Chapter-II

Project Planning

Audit objective: *Whether project was conceptualised after assessing the feasibility and viability of the project and taking into account the need of the command area?*

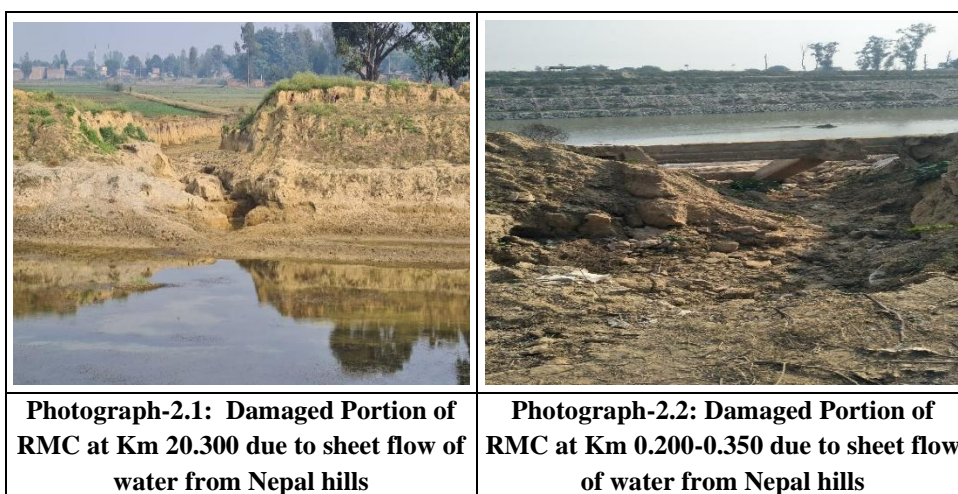
Audit examination of records disclosed that RMC was damaged in October 2022 from water flow of heavy rain. During joint physical verification (December 2022), Audit noticed severely damaged irrigation assets of RMC as depicted in the following photographs:

The above mentioned situations indicated that the left bank of RMC was not protected adequately from the flow of water, despite recommendations of CWC.

In reply, the State Government stated (November 2023) that all the main canals under the project were mainly conceived and constructed as contour canals. Contour canals are type of canals which are constructed depending on geographical condition and it is not possible to make technical changes in it. In respect of not providing safety to the left bank of RMC, the Government replied that on the basis of the suggestions of the Technical Experts Committee of CWC in July 2018, earth work was carried out to raise the embankment of Saryu Link Channel and Saryu Main Canal. Ditch drains in about 46.450 km length were constructed and the same was in progress at some other important places along RMC for providing proper drainage of water.
